# Talison Lithium Pty Ltd Greenbushes Lithium Mine Expansion

## Quarterly Monitoring Report (July to September 2025)

December 2025

Figure 5.4 TSF2 decant pond level for the quarter (July – September 2025)

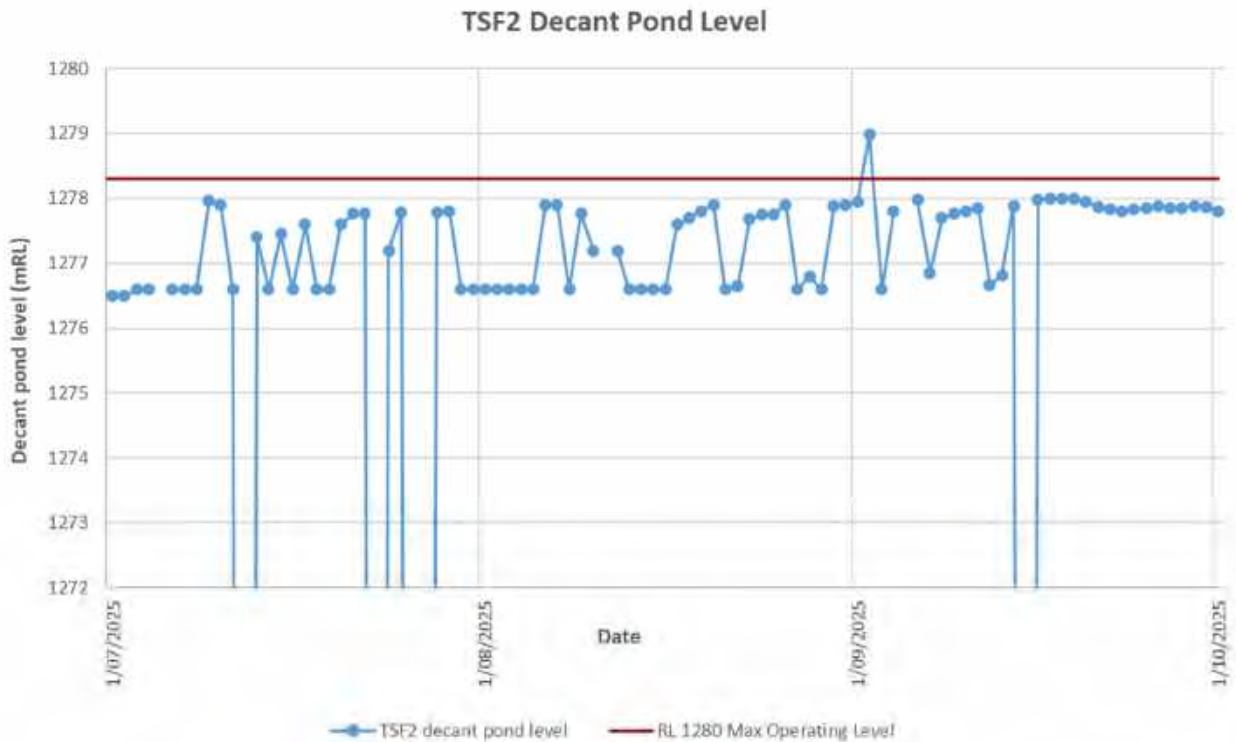
Over the quarter the recorded decant pond level predominately varied between approximately RL 1276.5 m and RL 1278 m. On 2 September 2025 the water level was recorded above the maximum operating level at approximately RL 1279 m. The decant pond level returned to RL 1277.8 m the following day. The decant level was not recorded and the records state “water below gauge” occasionally in July and September 2025. This is reflected as gaps in the graph shown in Figure 5.4.

Deposition during these months was ongoing, and there also were several rain events during this time. **The decant pump should be operated continuously in order to minimise the volume of water stored on the TSF.**

Figure 5.6 Volume of water pumped out of the seepage sumps

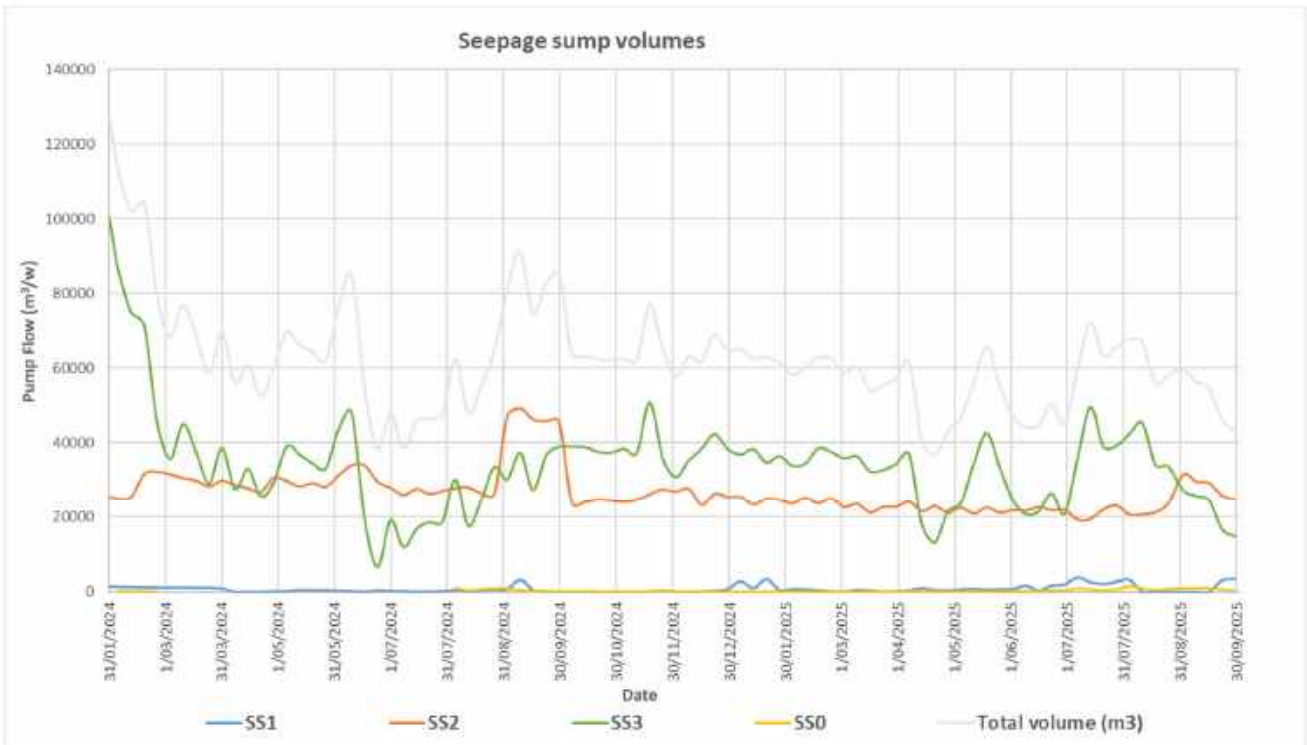
As shown on Figure 5.6 the recorded volumes of pumped seepage have historically been high, with a median volume of approximately 60,000 m<sup>3</sup> per week over the last 18 months. **The TSF2 seepage system should be reviewed, and an inspection of the component flowmeters, pumps and pipework should be undertaken to confirm that the recorded seepage flows are an accurate representation of the magnitude of the seepage being collected from the TSF.**

Figure 5.10 Movement of TSF2 survey pins in RL

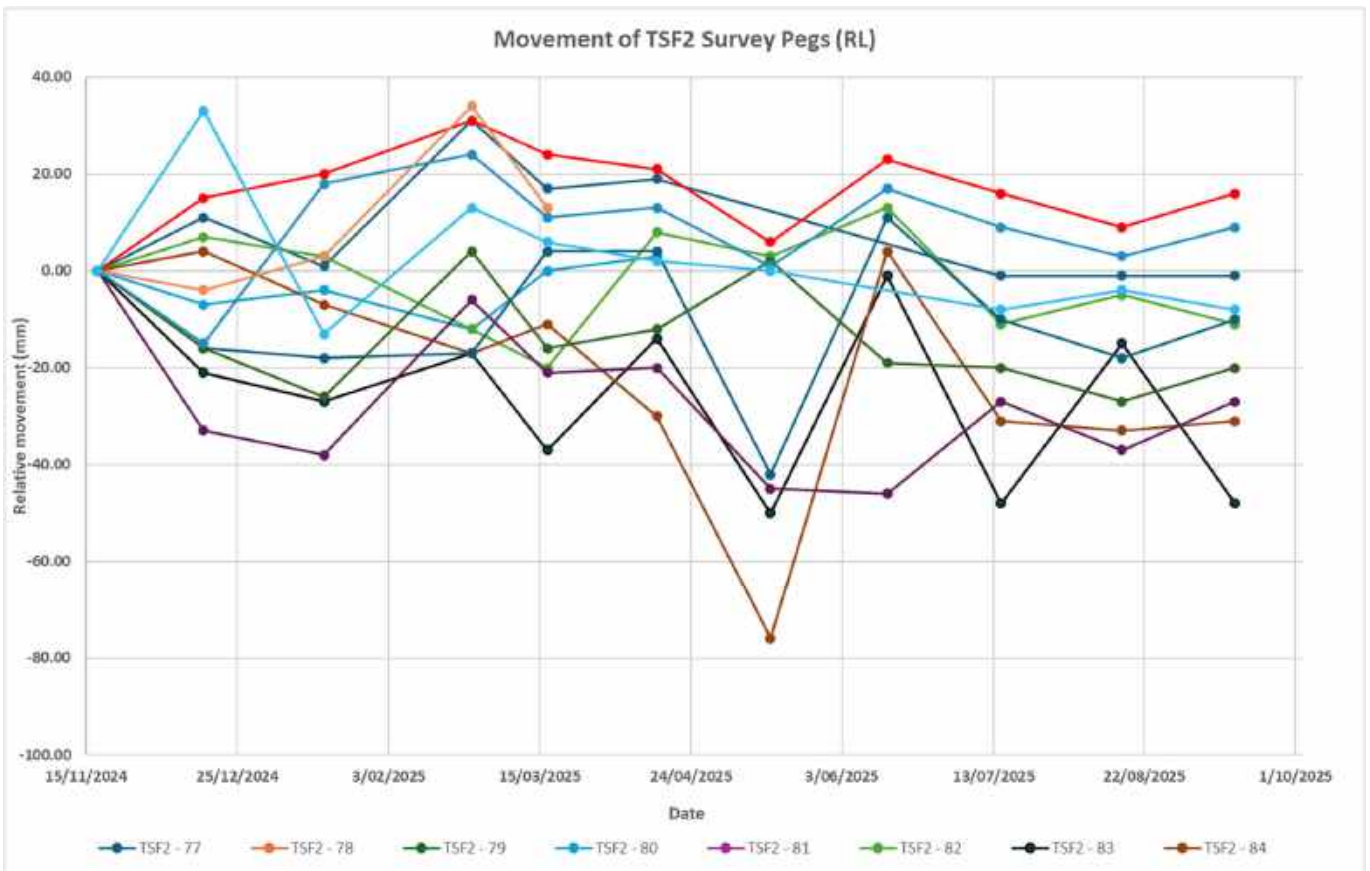
The embankment crest has experienced overall settlement of up to approximately 80 mm, corresponding to 0.3% of the 30 m embankment height. This is within the typically expected range for rockfill embankments (Hunter and Fell, 2003).

Figure 7.1 TSF4 aerial imagery – 22 September 2025

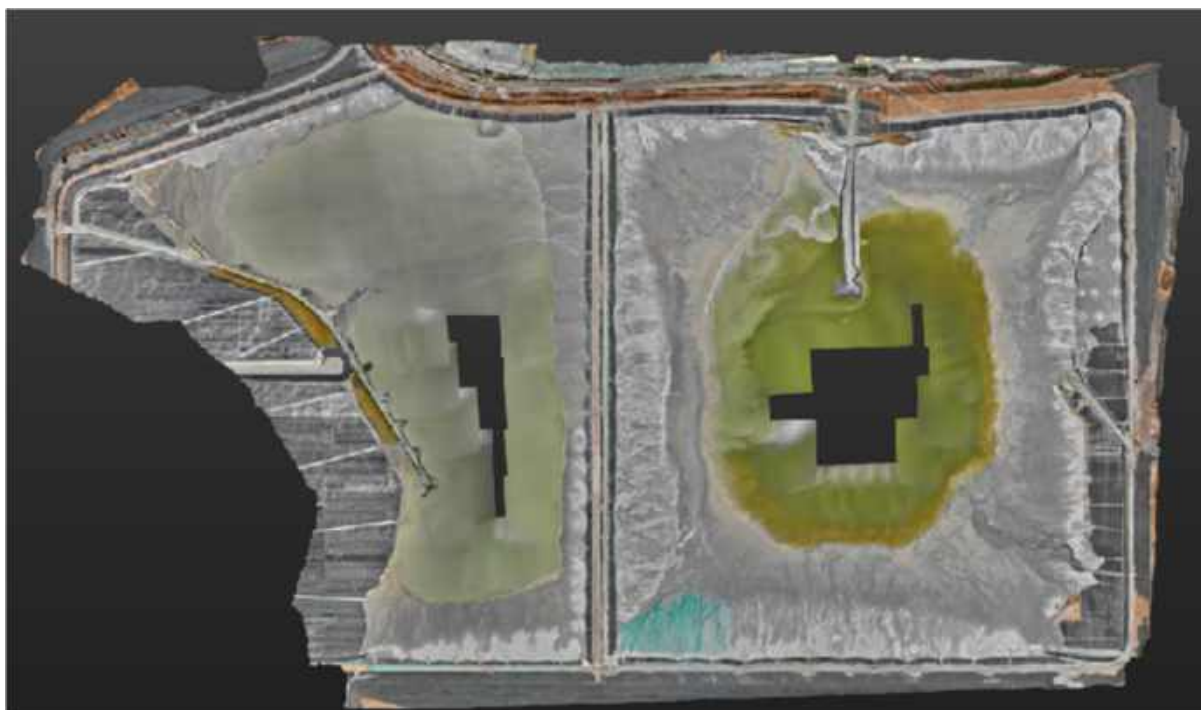
Inspection of the aerial imagery showed a large decant pond was present during the quarter as shown in Figure 7.1. The decant pond was located within 200 m of the embankment which is not in accordance with the operating procedures outlined in the OMM. ***The decant pond should be maintained at least 200 m from the perimeter embankments.***

Figure 7.2 Decant Pond level for TSF4 Cell 1 & Cell 2 since 1 January 2024

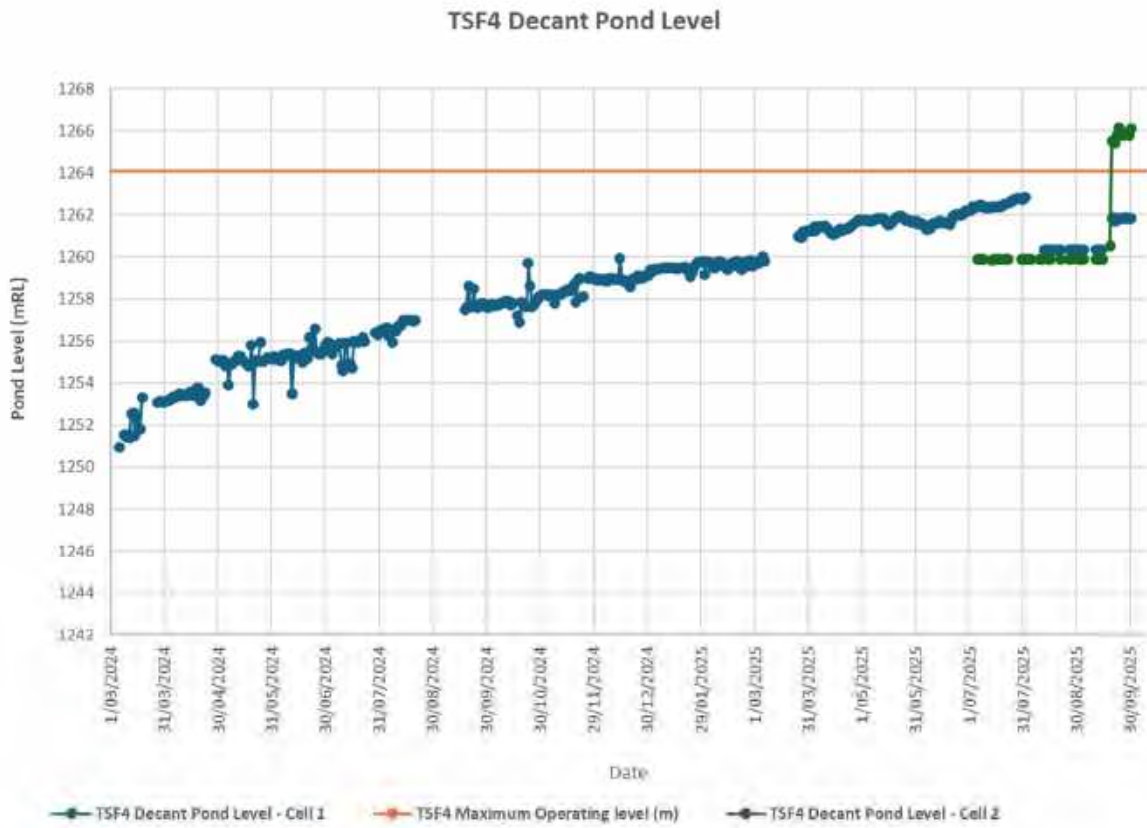
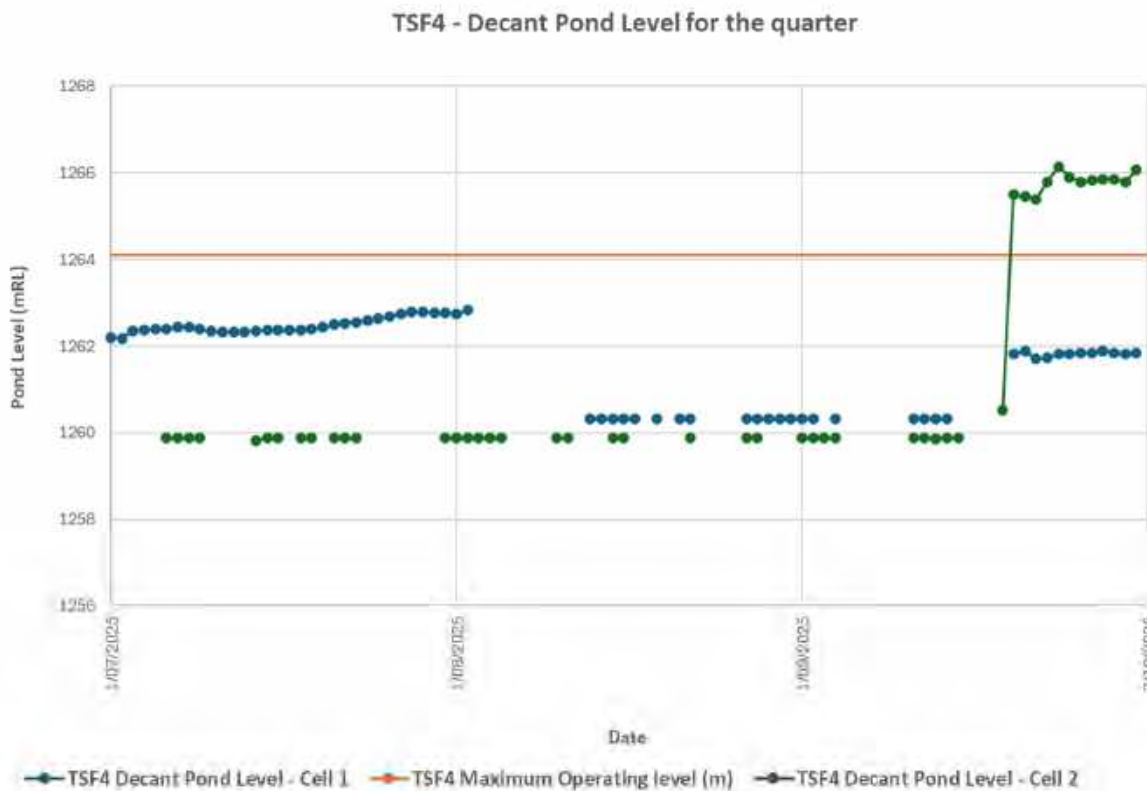
The recorded daily decant pond levels at TSF4 Cell 1 are shown in Figure 7.2 and Figure 7.3. The Cell 1 decant level remained below the maximum operating level at all times, however the Cell 2 decant level exceeded the maximum operating level on 21 September 2025 and remained above this level. ***The decant pond should be continuously pumped out of the facility to maintain the decant level below the maximum operating level at all times.***

Figure 7.4 Volume of water pumped in Sumps A and B

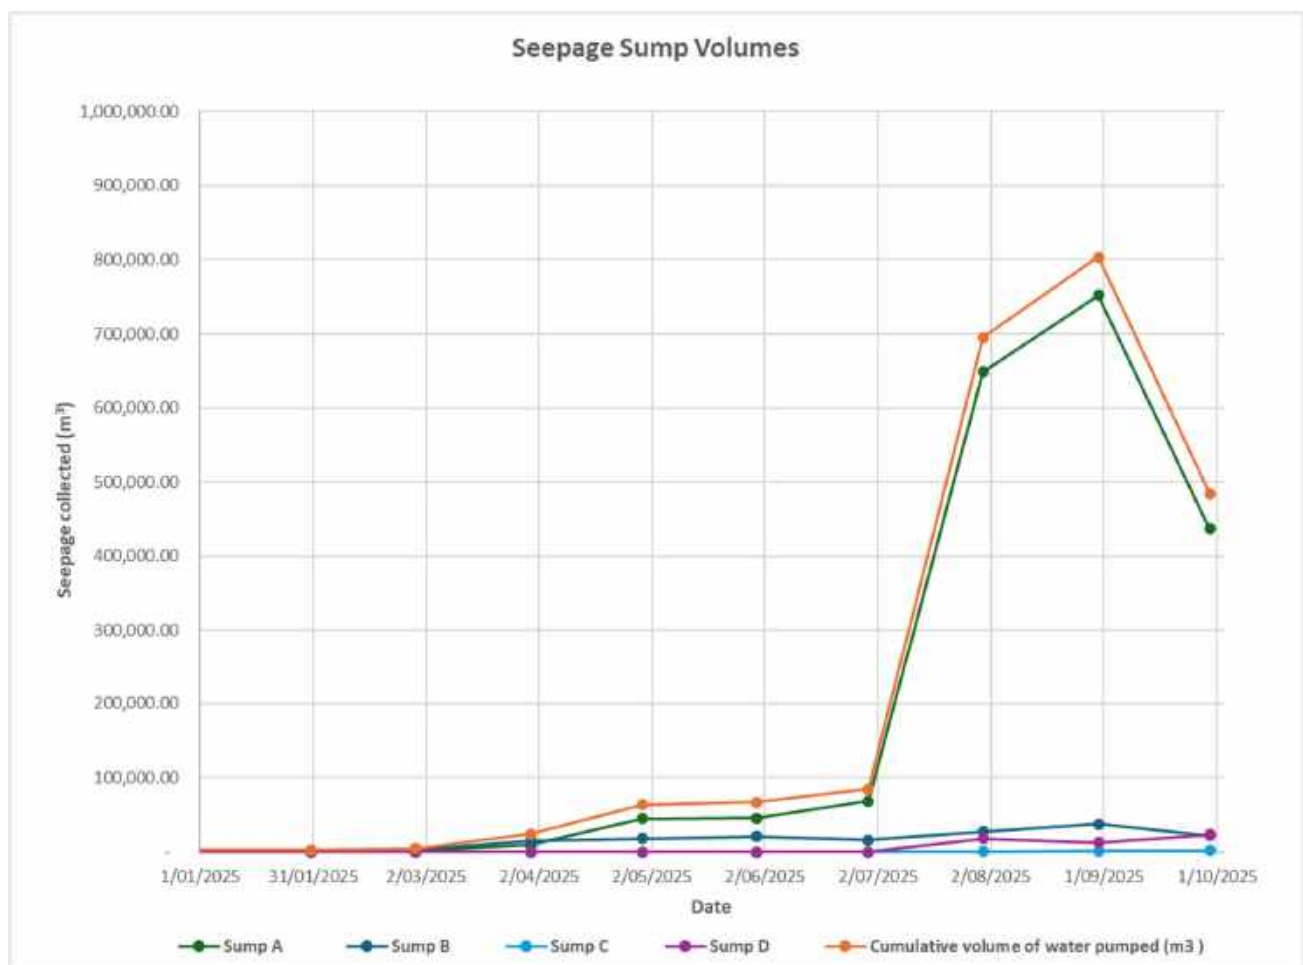
There are four collection sumps associated with TSF4, Sumps A to D. A total of **1,982,694 m<sup>3</sup>** was pumped from these sumps between 1 July 2025 and 30 September 2025. Figure 7.4 shows the seepage sump flows for the year to date. This volume is a significant increase compared to the volume pumped between first and second quarter of 2025 and is likely due to rainfall runoff from the downstream embankment face and other toe drain catchment areas.

The water collected in the collection sumps is currently pumped back to the decant pond. **Water collected in the seepage sumps should be pumped to CWD to avoid adding additional water onto the TSF.**

Figure 7.5 Construction VWPs (TSF4 Cell 1)

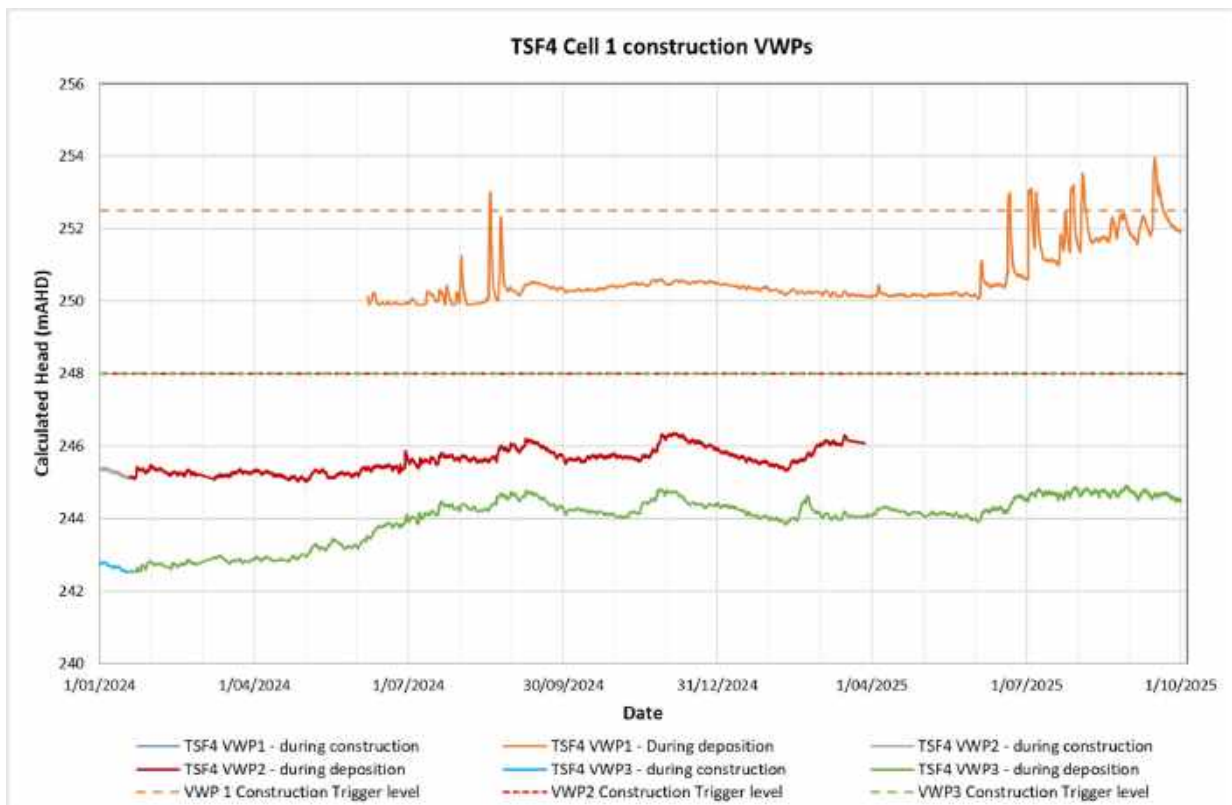
TSF4 VWP1 exceeded its trigger level during third quarter of 2025. This is anticipated to be a result of construction activities in the area (rock placement). **This piezometer should be monitored closely to see whether the readings continue to increase, stabilise or reduce.** TSF4-VWP2 stopped returning readings at the end of March 2025. **This piezometer should be investigated and repaired.**
